Case No.: ADD2004-00060

Project Name: Coconut Point MPD

ADD2004-00060(C) & ADD2004-00187(A), 11JAN06, COCONUT POINT MPD, CORRECTIONS TO THE ADMINISTRATIVE APPROVALS TAKEN IN ADD2004-00060, ADD2004-00060A, ADD2004-00060B AND ADD2004-00187.

EX 1

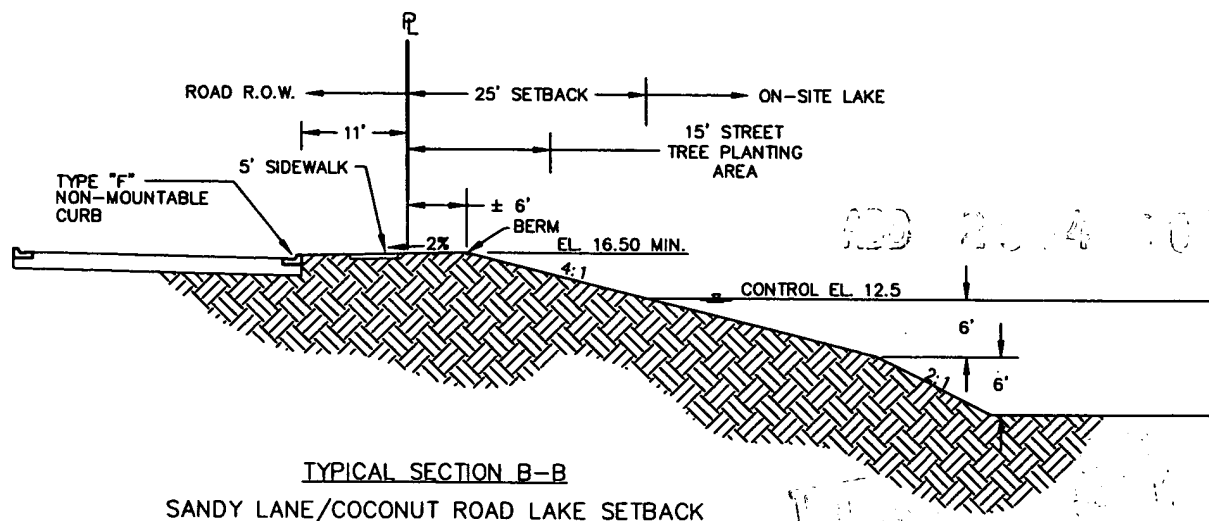
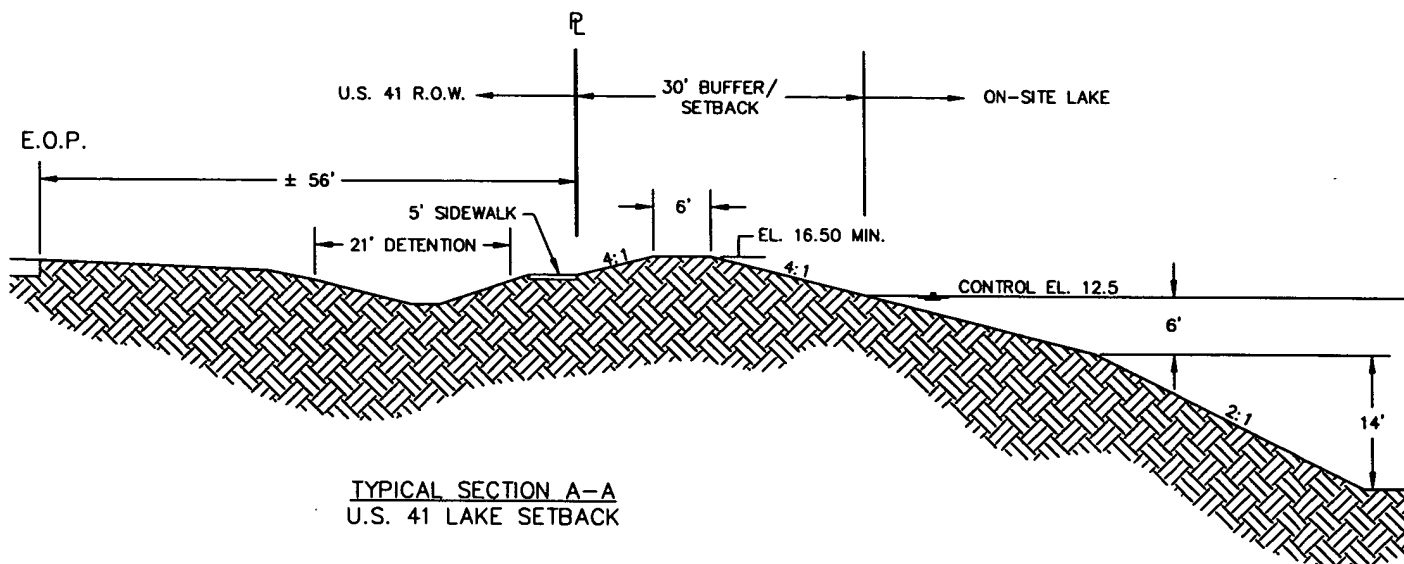
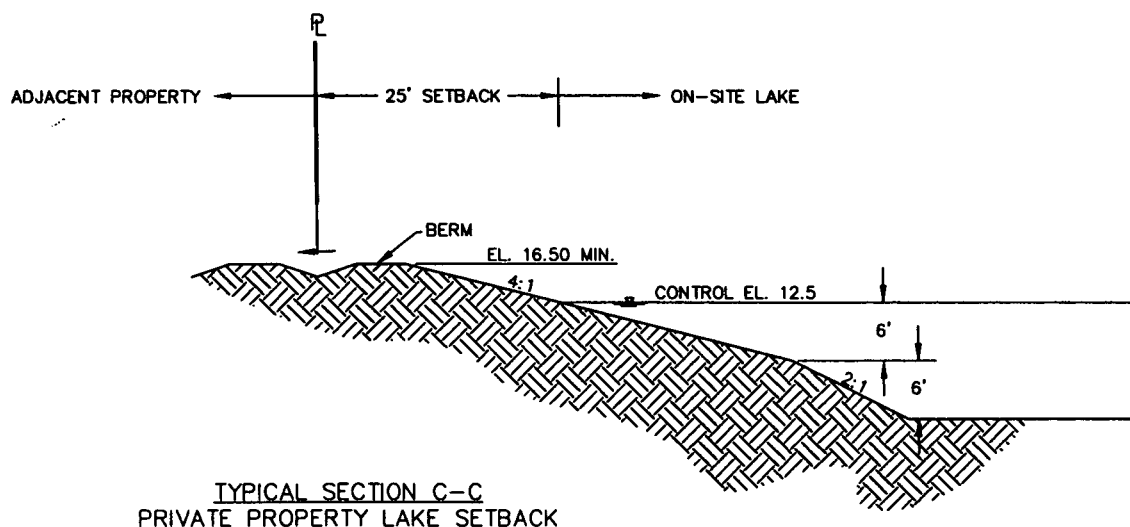
Justification for the deviation will be in the form of alternate provisions for protection of wayward vehicles as mentioned in the code section. At the U.S. 41 location, a surface water management berm 30 feet buffer/vegetation will be provided at the right of way line per Coconut Point Zoning Resolution #Z-02-009. In addition, a detention swale is located within the U.S. 41 right of way between the travel lanes and the eastern right of way line. At the Sandy Lane locations, a surface water management berm and 15' street tree planting area along with type "F" non-mountable curb and gutter will be utilized to provide protection of vehicles. At the private property line locations, a surface water management berm will be provided.

EXHIBIT 'O'

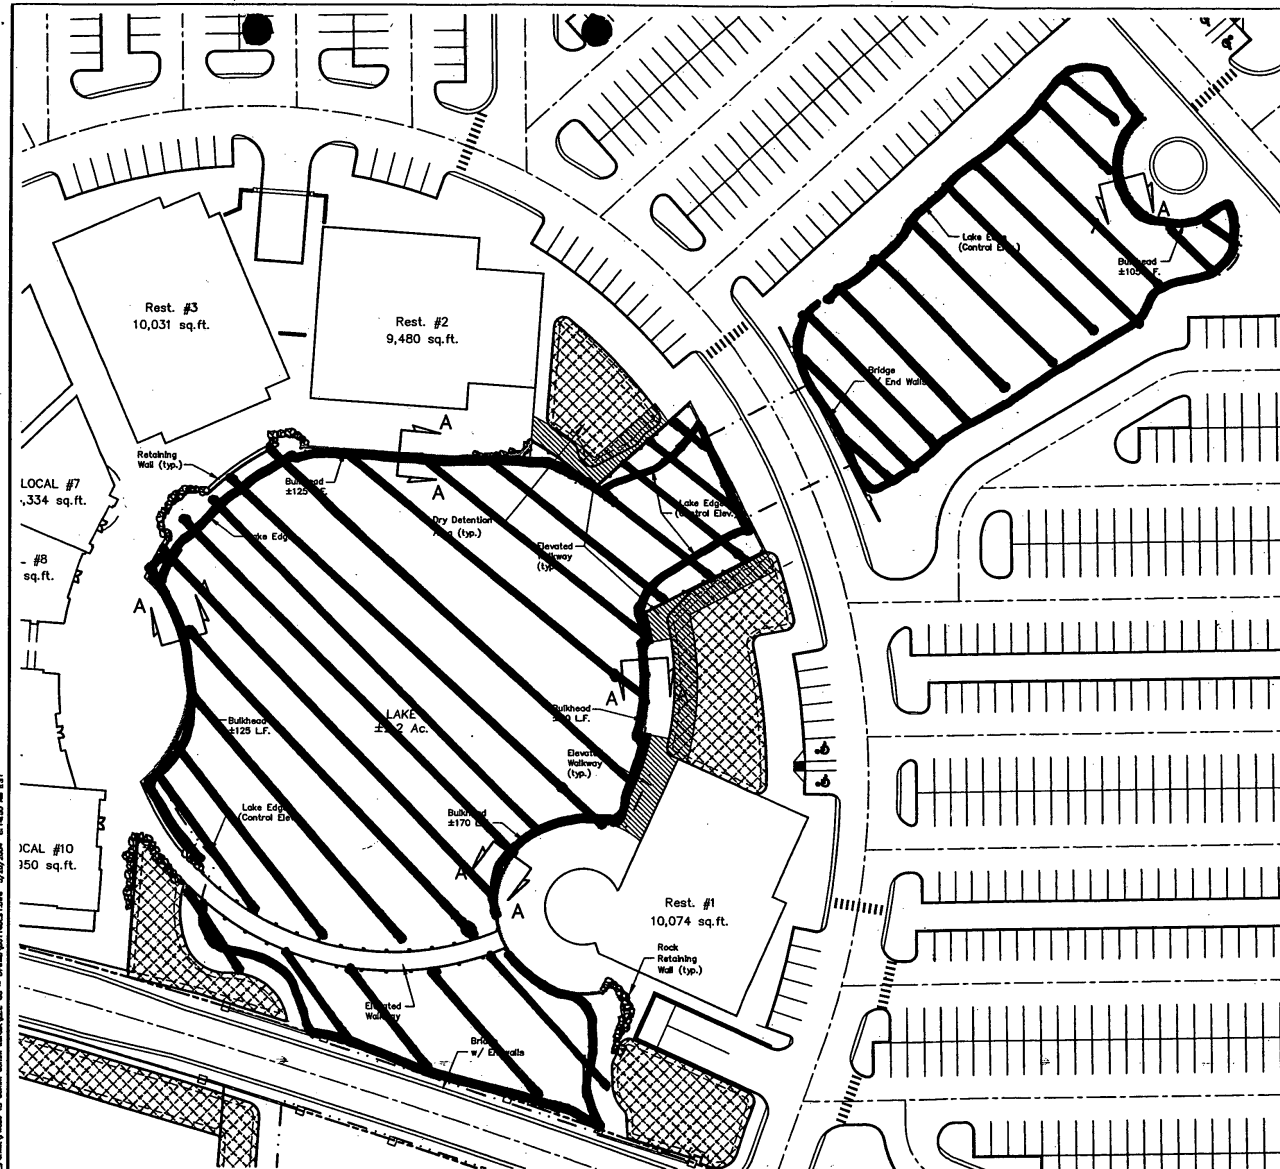
The applicant is requesting the use of bulkheads along portions of the lakes as delineated in the Bulkhead Exhibit (Attachment 'O'). The justification for the request is to create a unique retail/restaurant/outdoor amenity experience around a large, central lake feature, which will allow pedestrians close access to the water. The applicant recommends a condition to provide a compensatory littoral zone to offset the use of bulkheads.

If bulkheads are utilized in the final site design, then the Paving and Grading, and Landscape Plans must delineate the location of the bulkheads in substantial compliance with the attached Bulkhead Exhibit (attached hereto). The design of the lake adjacent to the bulkheads must include a compensatory littoral zone with a 4:1 slope with a 5-foot littoral shelf equivalent to the linear footage of the bulkhead along the bulkhead, or an alternative compensatory littoral zone reviewed and approved by the Division of Environmental Sciences. The littoral planting requirements within any lake utilizing bulkheads must be calculated as two (2) herbaceous littoral plants per linear foot of shoreline for the lakes delineated on the Bulkhead Planting Exhibit (attached hereto), and the placement of the littoral vegetation must be concentrated within the compensatory littoral zone. Native wetland trees and/or shrubs may be used to meet the littoral planting requirement with one 7-gallon tree or two 3-gallon shrubs credited as 10 herbaceous littoral plants.
